PUBLIC HEARING MEMORANDUM

SUBJECT: **Petition #293-21, SPECIAL PERMIT/SITE PLAN APPROVAL** to allow a 28-unit three-story multi-family dwelling with underground parking, to waive 26 parking stalls and to alter and extend a non-conforming front setback at **967 Washington Street, 92 and 96 Walker Street**, Ward 2, Newtonville, on land known as Section 21 Block 33 Lots 1-3, containing approximately 34,210 sq. ft. of land in a district zoned MULTI RESIDENCE 3. Ref: Sec. 7.3.3, 7.4, 3.4.1, 3.2.6, 7.8.2.C.2, 5.1.4, 5.1.13 of the City of Newton Rev Zoning Ord, 2017.

967 Washington Street, 92 and 96 Walker Street

Zoning Plan Newton, Ma
Showing Proposed Conditions
#967- # 979 Washington Street & #92 & # 96 Walker Street
Prepared by: VTP Associates Inc.
Dated: July 26, 2021
Revised: August 25, 2021

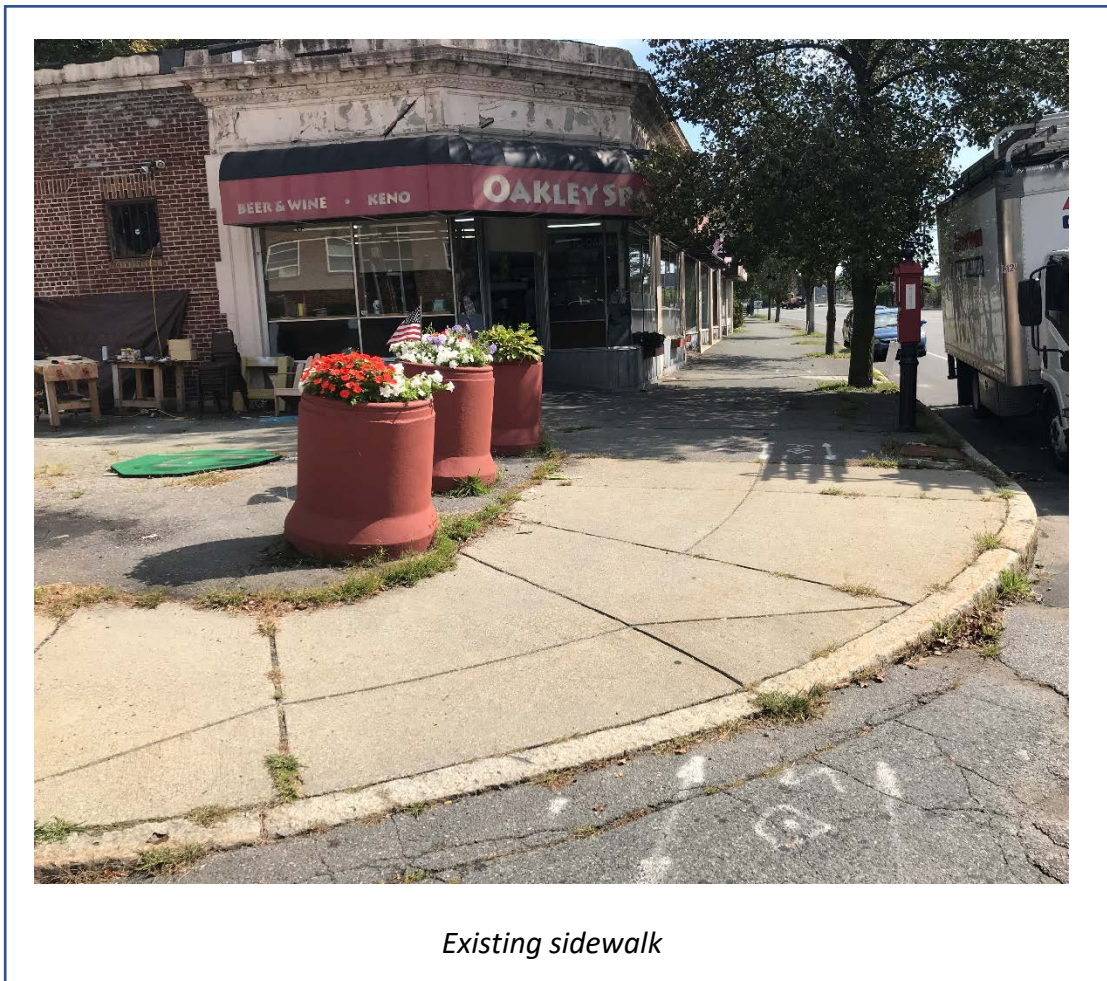
Various landscape walls of varying height will provide flat landscaped areas along Walker Street & Washington Street. The plan indicates updating the sidewalks surrounding the property however there is no indication about updating the pedestrian curb cuts (aka hp ramps) at the intersection. Both curb cuts shall be update at this intersection to current DPW Standards.

During the site visit yesterday a monitoring well head was discovered in back of the laundry matte what is the status of this well, is it being monitored by DEP?

A turning template plan of various sized vehicles is need for the parking garage to demonstrate adequate and safe maneuvering of vehicle entering and exiting the underground garage. Although sight distance should not be an issue, a warning sign to pedestrians should be provided when vehicles are exiting the garage.
